Engineering Change Order (ECO)

ECO #: ECO-SK-001-4S-T-001

Title: Upper skid pod assembly modification for Blueview use

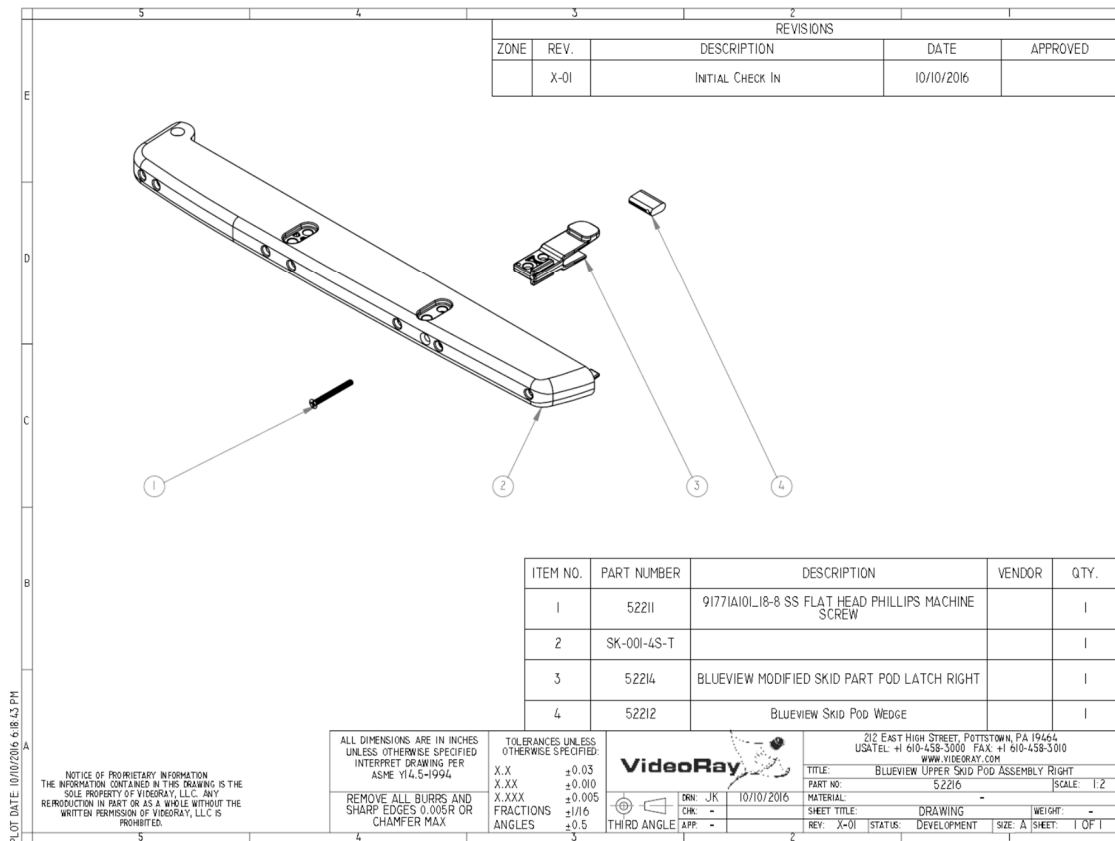
This ECO describes the production modification of the upper skid pod(s) for use when mounting the blueview skid (non slim mount).

This corrective action addresses the latch cracking issue caused by excessive stress on over flexing of the post modified skid latch.

The problem is remedied by the installation of wedge that prevents excessive stress on single sided latch.

Part number SK-001-4S-L is modified as is currently done to support mounting of the blueview sonar.

Part number 52212 is inserted into the latch and secured with flat head machine screw (52211)
